Comments on Item # 325 Zoning Advisory Committee Meeting are as follows:

SW/S Homberg Avenue, 325 feet NW of SE/S E. Homberg Avenue

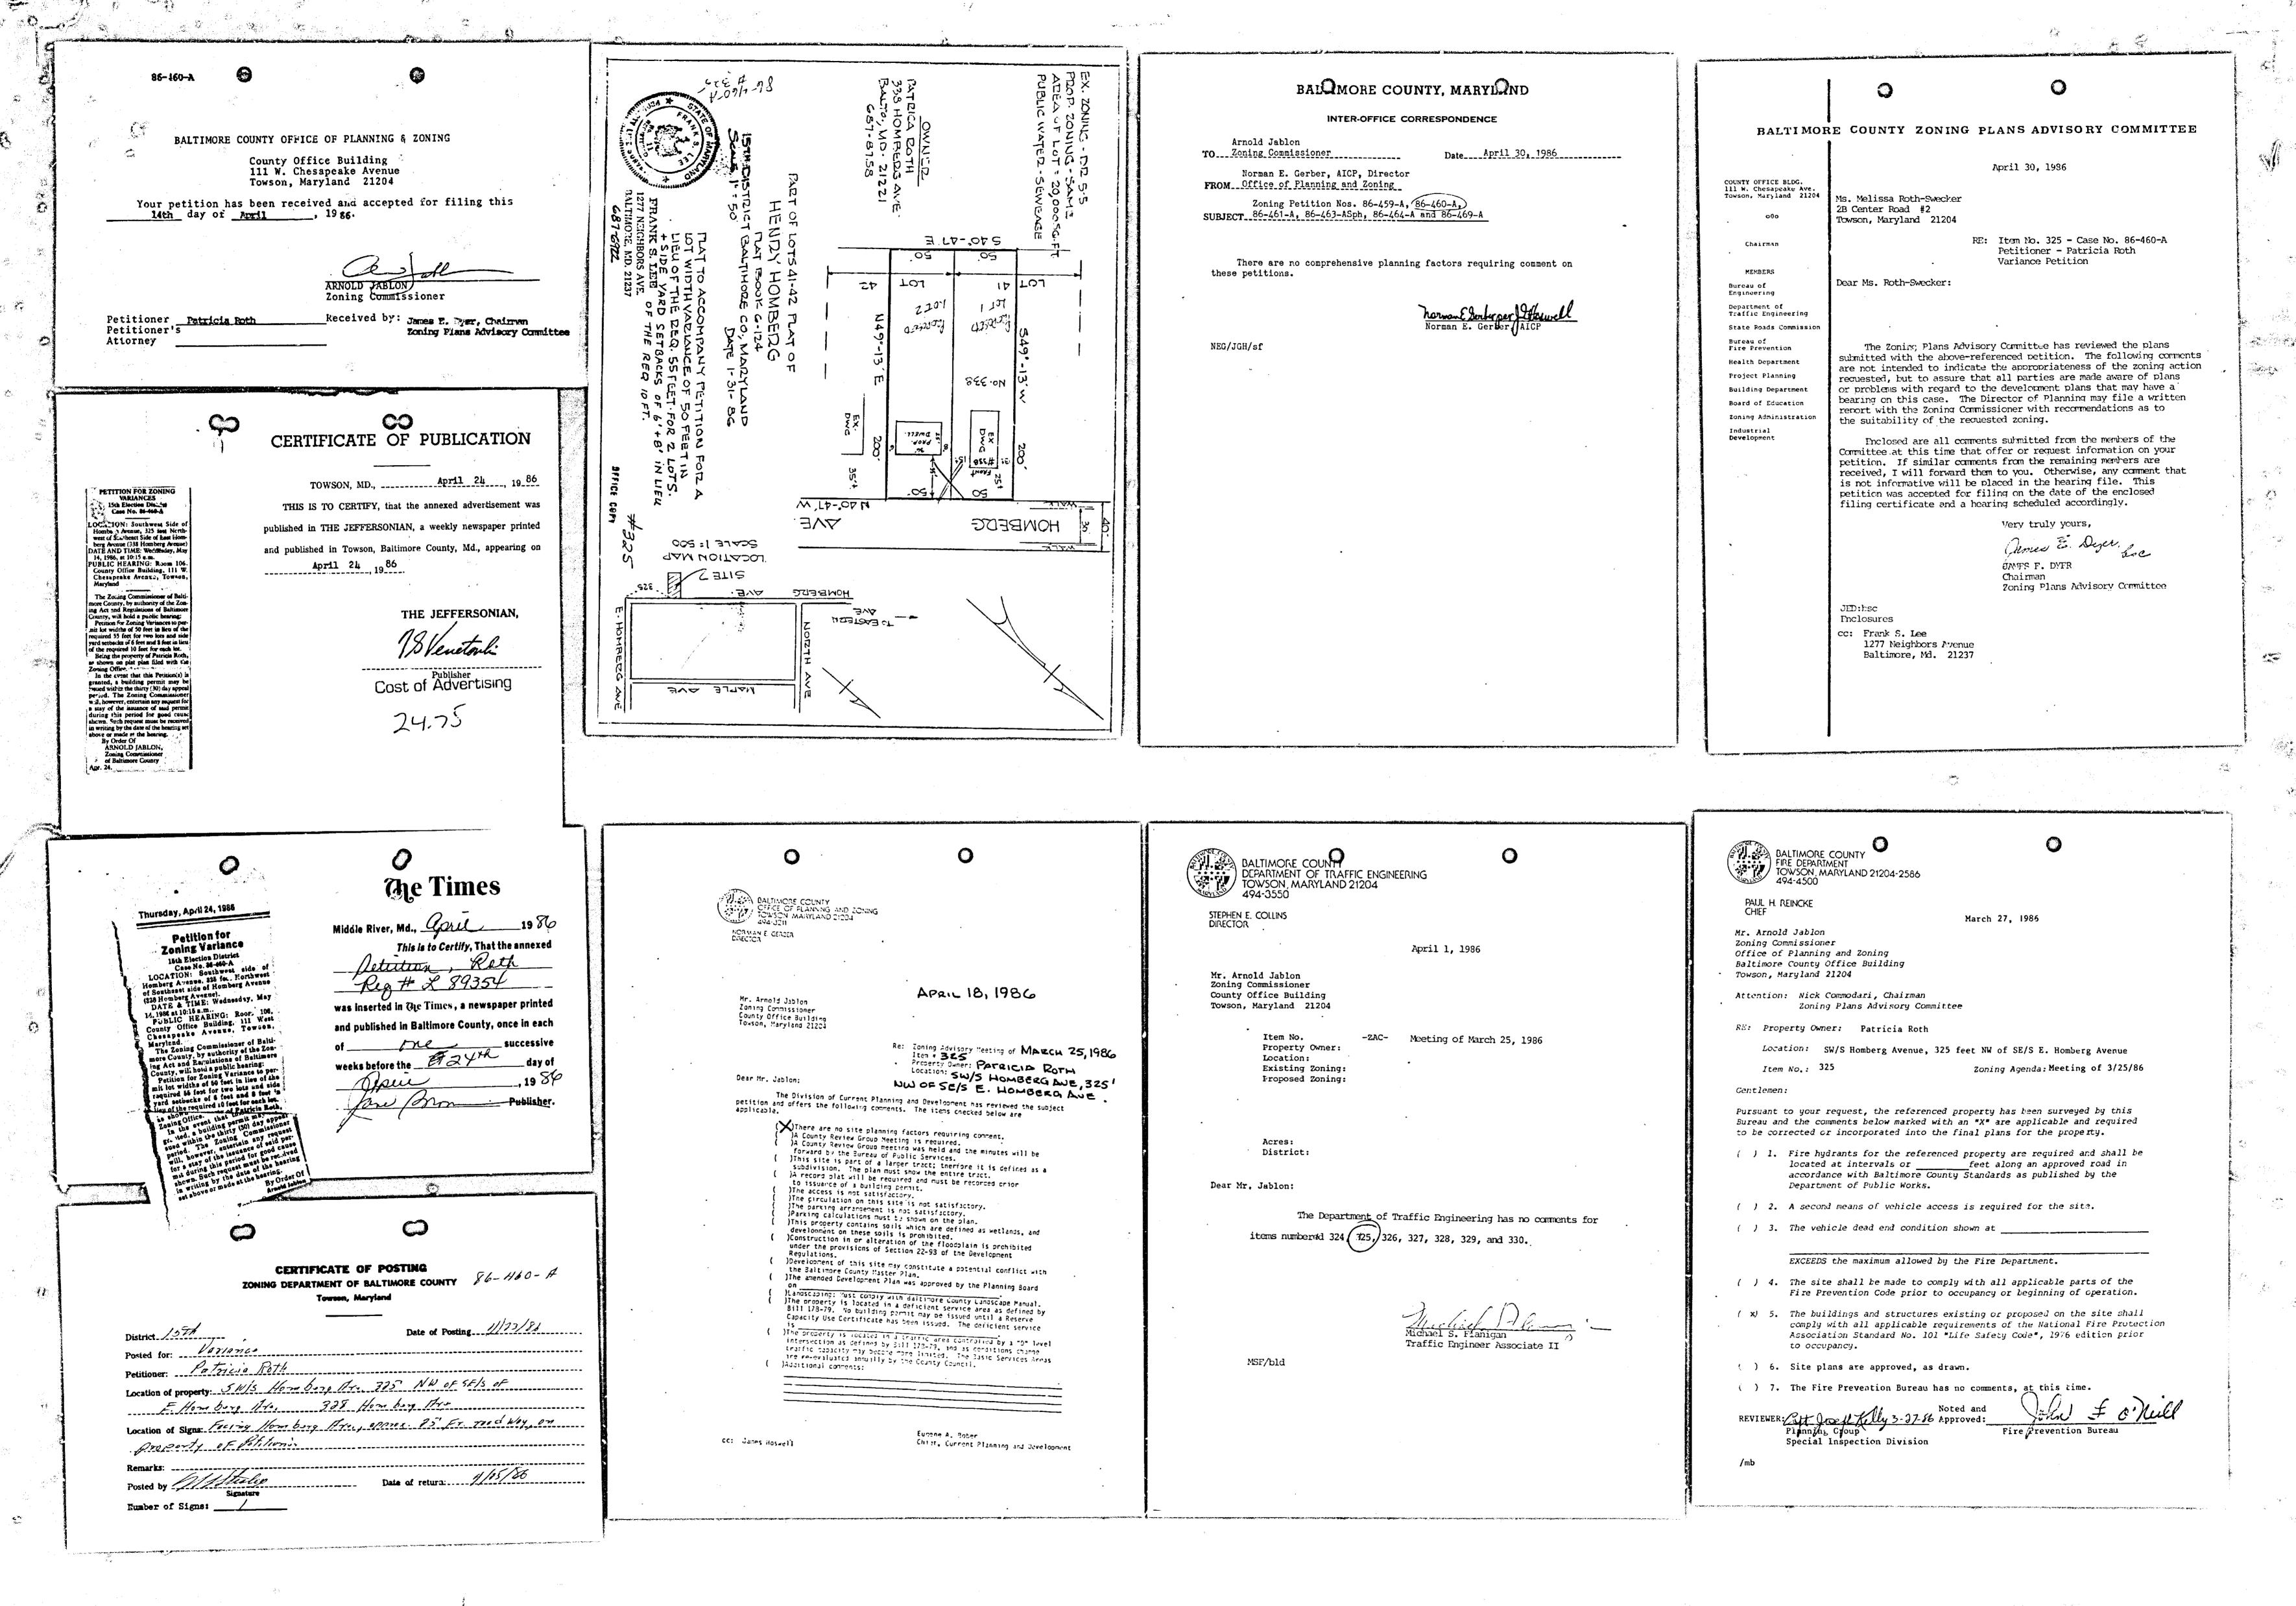
All structures shall conform to the Haltimore County Building Code as adopted by Council Bill #17-85, the Maryland Code for the Handicapped and Aged (A.N.S.I. #117-1 - 1980) and other applicable Codes and Standards.

- B A building and other miscellaneous permits shall be required before the start of any construction.
- C. Residential: Two sets of construction drawings are required to file a permit application. The seal of a registered in Maryland Architect or Engineer is/is not required on plans and technical data.

- E. All Use Groups except R-4 Single Family Detached Devellings require a minimum of 1 hour fire rating for exterior walls closer than 6'-0 to an interior lot line. R-4 Use Groups require a one hour wall if closer than 3'-0 to an interior lot line. Any wall built on an interior lot line shall require a fire or party wall. See Table 401, Section 1407, Section 1406.2 and Table 1402. No openings are permitted in an exterior wall within 3'-0 of an interior lot line.

- F. The structure does not appear to comply with Table 505 for permissable height/area. Reply to the requested variance by this office cannot be considered until the necessary data pertaining to height/area and construction type is provided. See Table 401 and 505 and have your Architect/Engineer contact unis department.

- I. The proposed project appears to be located in a Flood Plain, Tidal/Riverine. Pleass see the attached cupy of Section 516.0 of the Building Code as adopted by Bill #17-85. Site plans shall show the correct elevations above sea level for the lot and the finish floor levels including basement.
